ADDENDUM No. 06

- A. Project Name: 2024 CAPITAL PROJECT PHASE 1.
- B. Building(s): MAIN BUILDING
- C. Owner: AFTON CENTRAL SCHOOL DISTRICT.
- D. Architect: HIGHLAND ASSOCIATES.
- E. Architect Project Number: 2025-005P.
- F. Construction Manager: SCHOOLHOUSE CONSTRUCTION SERVICES.
- G. Date of Addendum: DECEMEBER 17, 2025.

1
A-402
AGRICULTURE LAB / CTE
DEMOLITION PLAN- GROUND FLOOR
SCALE: 1/8"=1'-0"

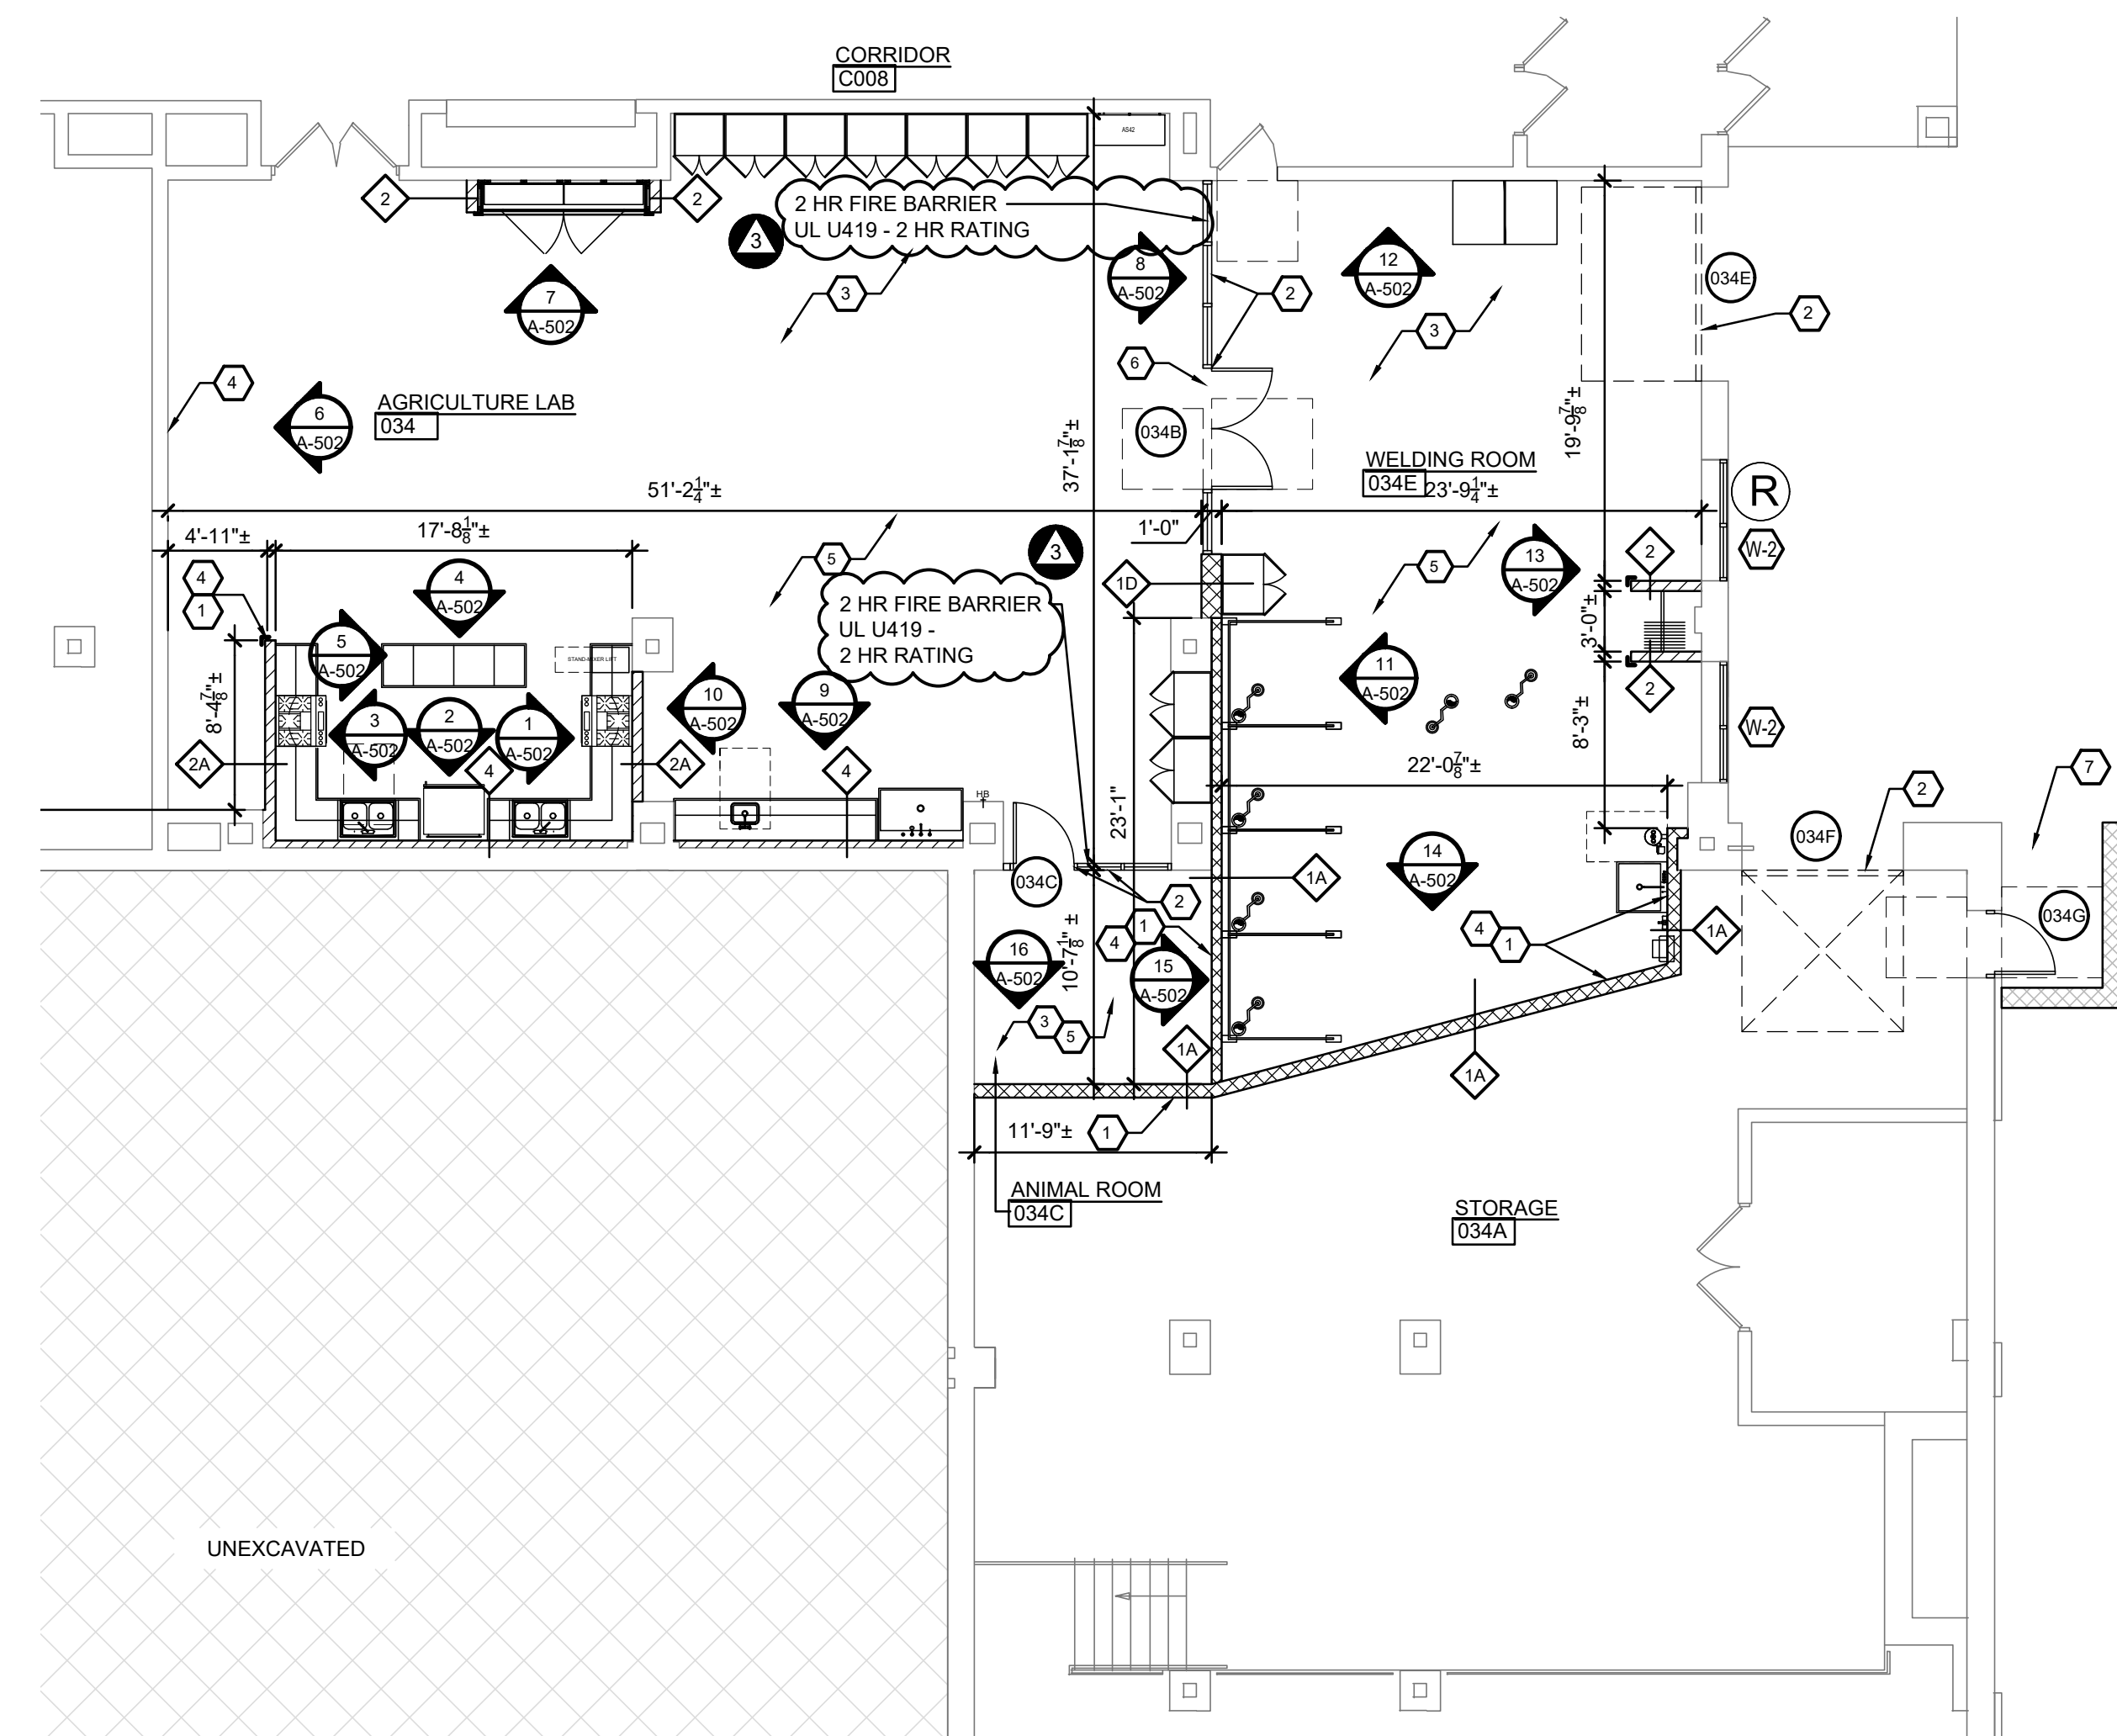
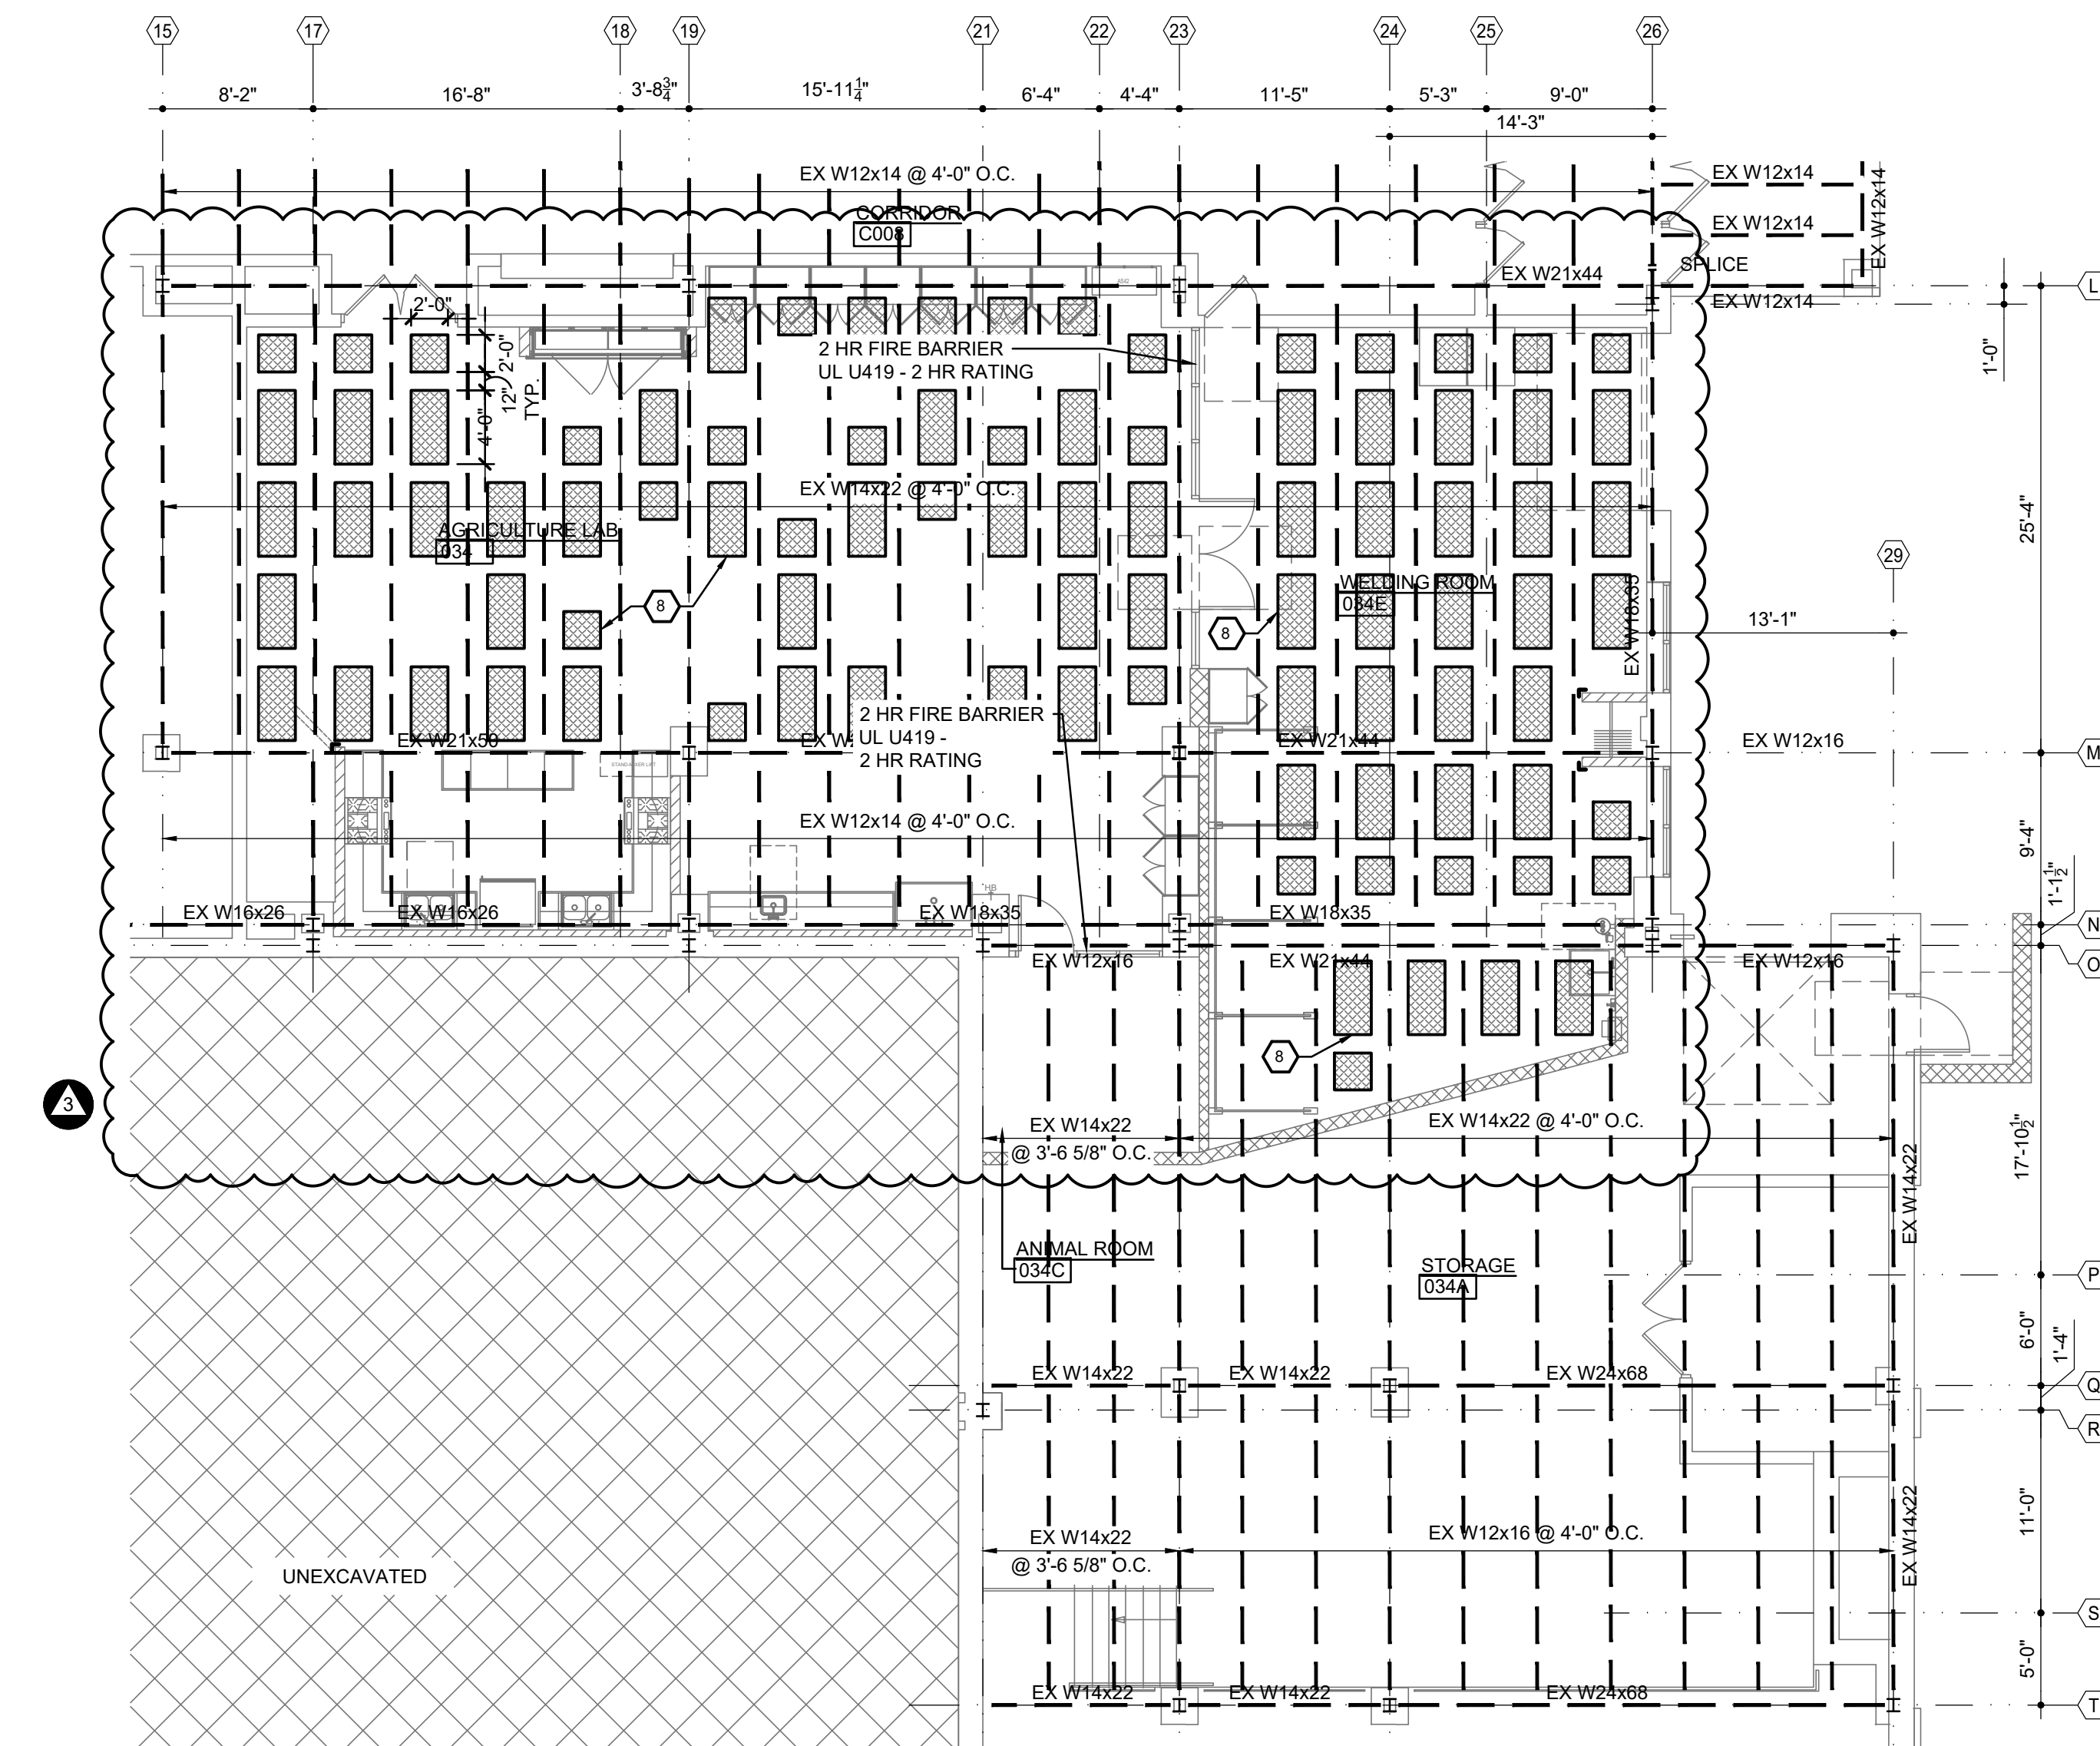
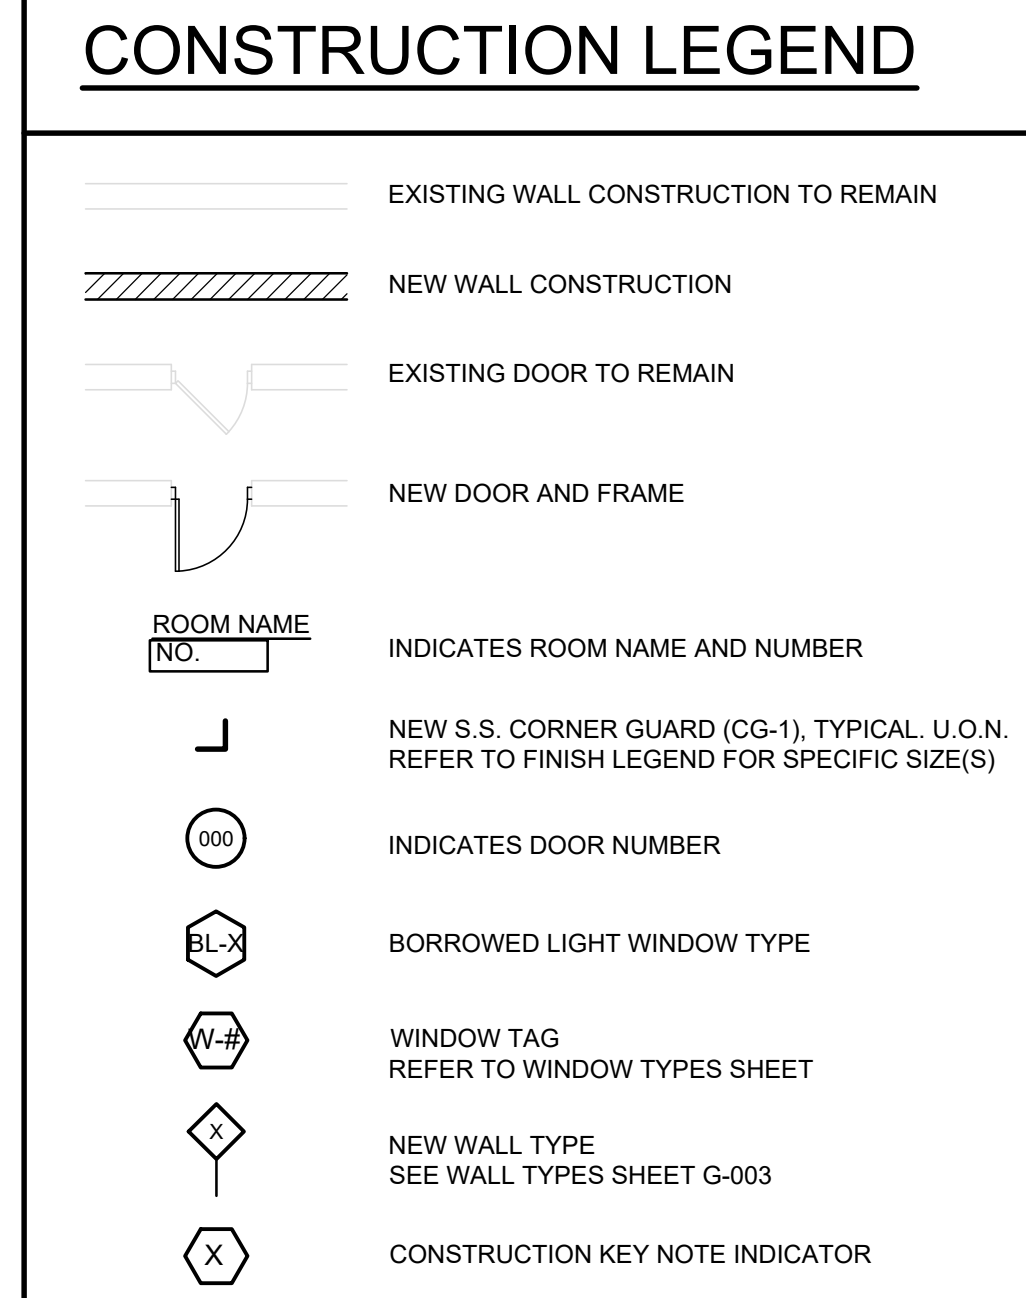
At Doors 034B and 034C, wall shall be fire rated drywall and metal stud partition.
Revised A-402 is issued herewith.

REQUEST: Can you give a better detail on how
fire proof, 1" furring strips, 3lb. Density
fiberglass, acoustic ceiling panels and
light go together in ceiling at Ag Lab.

The acoustical sound panels are revised to suspended mounting in lieu of direct attach to deck. The hexagon acoustical ceiling panels are part of the lighting fixture and will be provided by the Electrical Contractor. Revised A-401 and A-701 are issued with this addendum.

- ADDED NOTE 8 TO AG LAB/CTE CEILING PLAN.
- REVISED PARTITION TYPE TAGS AT KITCHEN AREA IN AGRICULTURAL LAB 034.
- ADDED S.S. CORNER GUARDS AT WELDING ROOM CLOSET WALLS & AT AG LAB WING WALL.
- ADDED ACOUSTICAL PANEL INFILL COLORS TO REFLECTED CEILING PLAN AT AG LAB.
- UPDATED NOTES FOR ACOUSTICAL INFILL PANELS AT HEXAGON PENDANT LIGHT FIXTURES.
- UPDATED CONSTRUCTION KEY NOTE #7 TO INCLUDE STRUCTURAL PLAN AT RETAINING WALL.

- ADDED STRUCTURAL FRAMING PLAN.

- REVISED CONSTRUCTION KEY NOTE #8.
- ADDED ACOUSTIC CEILING PANELS TO FRAMING PLAN.
- RELOCATED CONSTRUCTION KEY NOTE #8 TAG FROM REFLECTED CEILING PLAN TO FRAMING PLAN.
- ADDED PARTITION TYPE TO WALL BETWEEN AG. LAB AND WELDING ROOM.
